Landscape Referral Response

Application Number:	DA2024/1091
Date:	16/10/2024
Proposed Development:	Demolition works and construction of a mixed use development with basement parking comprising of retail uses and a childcare centre, including signage
Responsible Officer:	Anne-Marie Young
Land to be developed (Address):	<p>Lot 5 S/P 32656 , 5 / 1 Careel Head Road AVALON BEACH NSW 2107</p> <p>Lot 5 S/P 32656 , 5 / 1 Careel Head Road AVALON BEACH NSW 2107</p> <p>Lot B DP 385973 , 3 Careel Head Road AVALON BEACH NSW 2107</p> <p>Lot 3 S/P 32656 , 3 / 1 Careel Head Road AVALON BEACH NSW 2107</p> <p>Lot 3 S/P 32656 , 3 / 1 Careel Head Road AVALON BEACH NSW 2107</p> <p>Lot 7 S/P 32656 , 7 / 1 Careel Head Road AVALON BEACH NSW 2107</p> <p>Lot 7 S/P 32656 , 7 / 1 Careel Head Road AVALON BEACH NSW 2107</p> <p>Lot 1 S/P 32656 , 1 / 1 Careel Head Road AVALON BEACH NSW 2107</p> <p>Lot 1 S/P 32656 , 1 / 1 Careel Head Road AVALON BEACH NSW 2107</p> <p>Lot 4 S/P 32656 , 4 / 1 Careel Head Road AVALON BEACH NSW 2107</p> <p>Lot 4 S/P 32656 , 4 / 1 Careel Head Road AVALON BEACH NSW 2107</p> <p>Lot 6 S/P 32656 , 6 / 1 Careel Head Road AVALON BEACH NSW 2107</p> <p>Lot 6 S/P 32656 , 6 / 1 Careel Head Road

Fig. Trees 1 and 2 TPZ overlaid to the proposed basement level

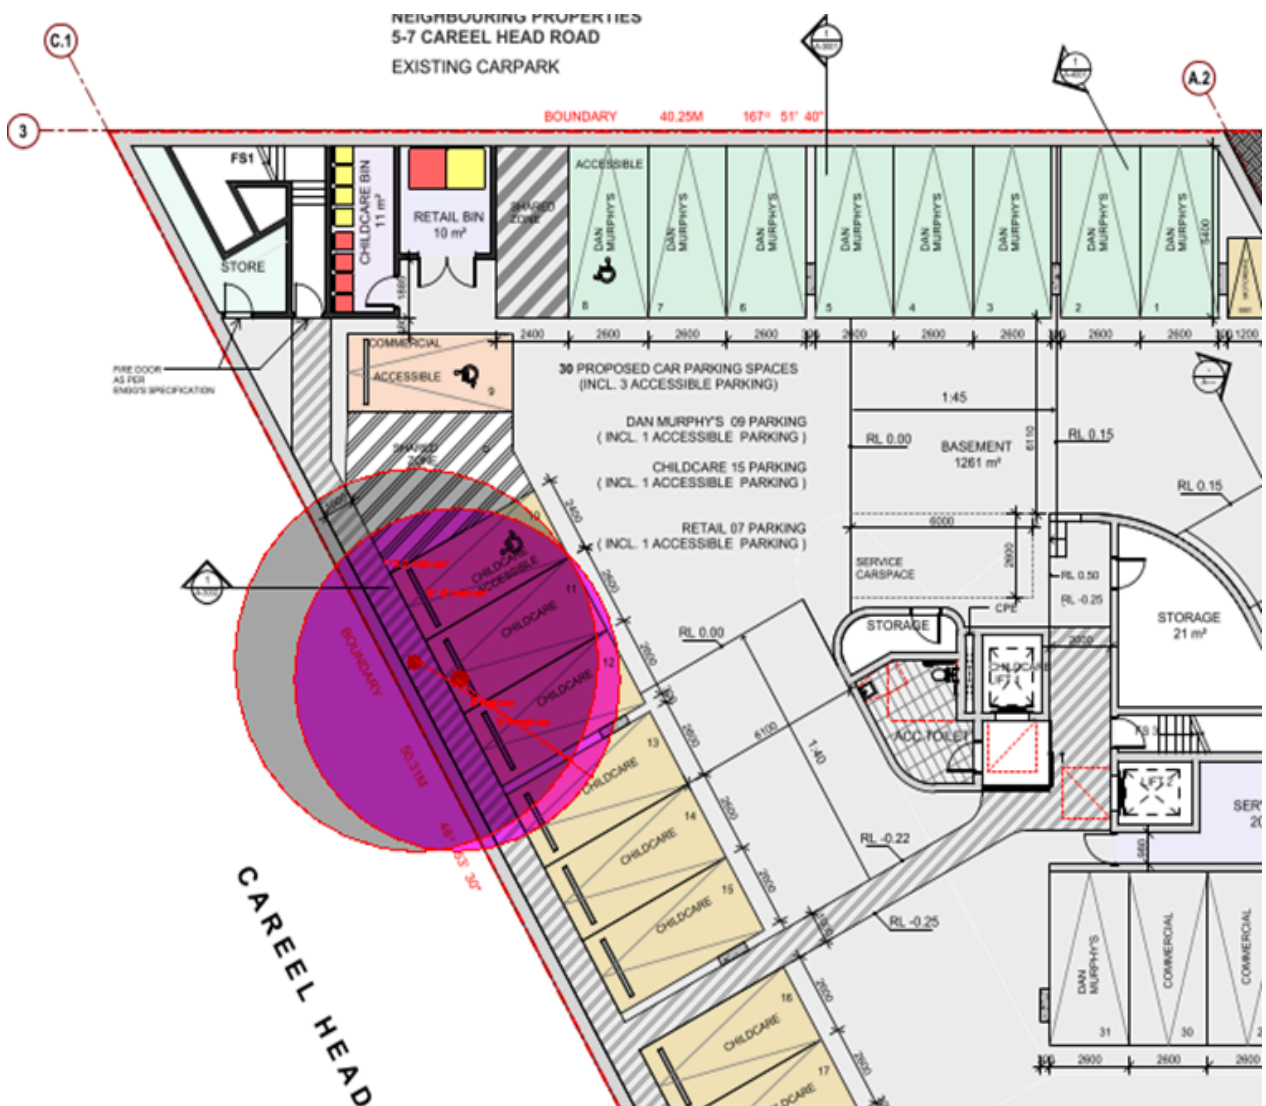
1. Retention of Trees 1 and 2.

Removal of the Norfolk Island Pine and Swamp She Oak are not supported. The trees provide a significant element in the local landscape . The trees are indicated in the Arborist's report as being High retention value trees.

Based on the Tree Protection Zone of the trees as provided in the Arborist's Report (Figs 1 and 2 below), the setbacks required to retain the trees are overlaid to the proposed development as follows:

Given the size of the site, it is considered that the setback required to retain the trees is achievable. Consideration of the planning controls and benefits to the childcare centre indicates that the retention of the trees is desirable. It is considered that the trees should be retained in the re-development of the site.

Fig.3 Hard paved areas around the proposed building

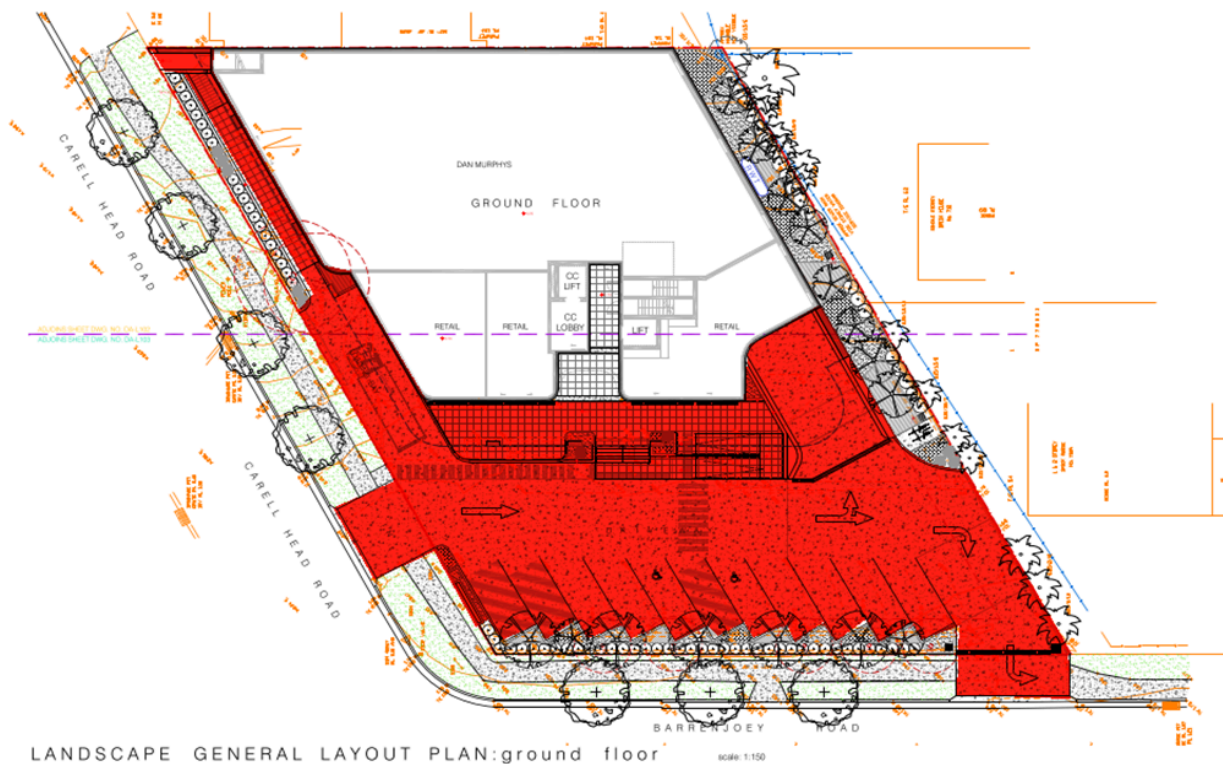
The plans indicate that the landscape setting of the proposed development results in a predominance of hard surfaces to the Careel Head Road and Barrenjoey Road frontage of the site. Fig. 3 indicates the extent of hard paved area that present to the public interface.

The landscape Plans indicate the provision of an 800mm wide (soil width) raised planter constructed above slab along Careel Head Road. The planter is indicated to provide small shrubs and groundcovers. No screening of the building bulk is provided by the planter and no screening of the loading bay is provided.

The Landscape Plans provide angled planting forward of the parking bays fronting Barrenjoey Road.

The proposed planting width varies between 2 m and 750mm, resulting in an average width of 1.38m.

The planning controls require a more substantial landscape setback.

The landscape planting and landscape outcome proposed is not considered to provide the outcome as envisaged by the planning controls.
